Service Bulletin No. 402

MODEL	J4500 Series	TYPE	Field Change Program	SECTION/GROUP	9-Fuel	DATE	Oct. 23, 2013
SUBJECT	DD13 DEF NOZZLE SUPPLY HOSE AND METERING UNIT FITTING						
CONDITIONS

Figure 1.

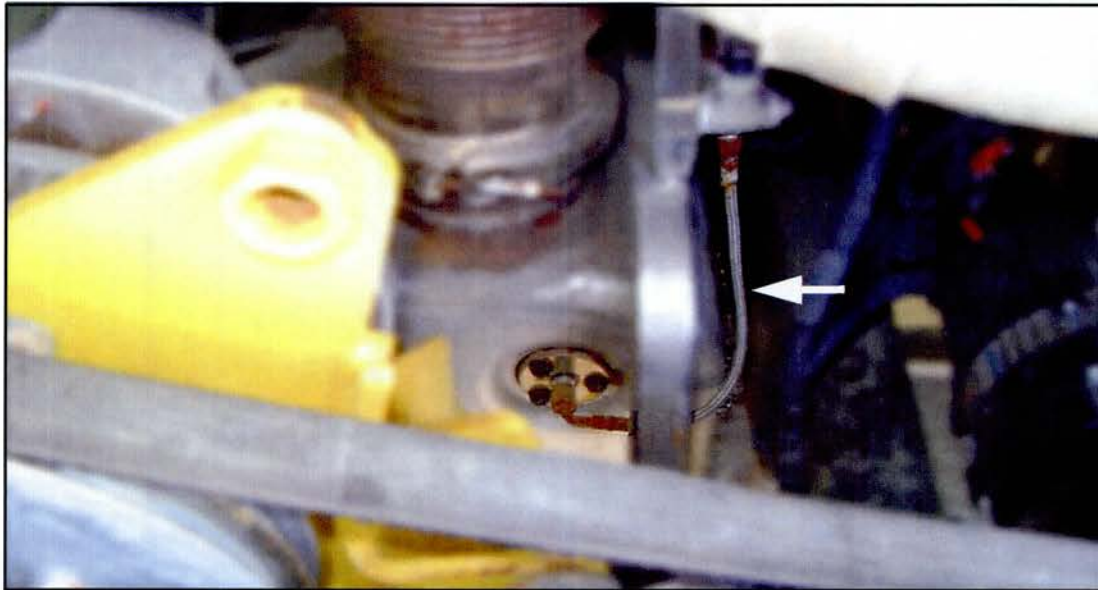
Motor Coach Industries ("MCI") has become aware that the incorrect diesel exhaust fluid (DEF) nozzle supply hose and metering unit fitting was utilized on J4500 series coaches equipped with a DD13 2010 EPA engine.

The incorrect parts could result in leaking DEF, the CHECK ENGINE tell-tale light illuminating on the instrument panel and if not addressed, the coach will initiate the engine shutdown sequence.

Incorrect part for application.

1. Turn the main disconnect switch to the OFF position.
2. Chock both sides of the tires.
3. Open the engine compartment door. Position the ENGINE RUN and ENGINE START switches on the engine remote control box to the OFF position.
4. Locate the stainless steel DEF nozzle supply hose on the selective catalytic reduction exhaust aftertreatment unit (SCR) in the lower, roadside section of the engine compartment (refer to Figure 1).
5. Remove and discard the DEF nozzle supply hose (refer to Figure 1).
6. Orient and install the new DEF nozzle supply hose, p/n 08-20-2409. Torque ends to 11-12 ft.-lbs.

Figure 3.

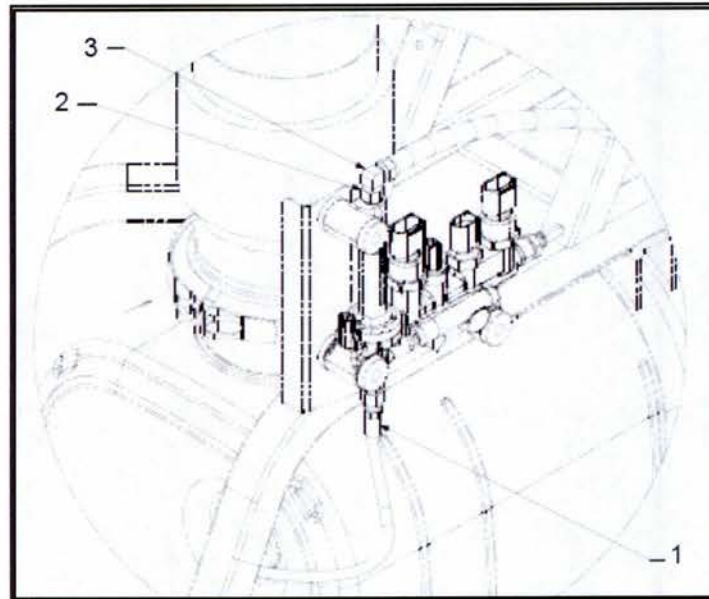
7. Locate the 90 degree fitting on top of the dosing metering unit, directly above the DEF nozzle supply hose installed in Step 6 (refer to Figure 2)
8. Remove and discard the existing 90 degree fitting on top of the dosing metering unit (refer to Figure 2)

9. Orient and install the adapter, p/n 19-10-3010 (refer to Figure 3). Torque the adapter to 6-9 ft.-lbs.
10. Orient and install the fitting, p/n 19-10-1403. Cut 0.50 inch off the end of the hose. Connect the hose to the fitting. Tighten to secure.
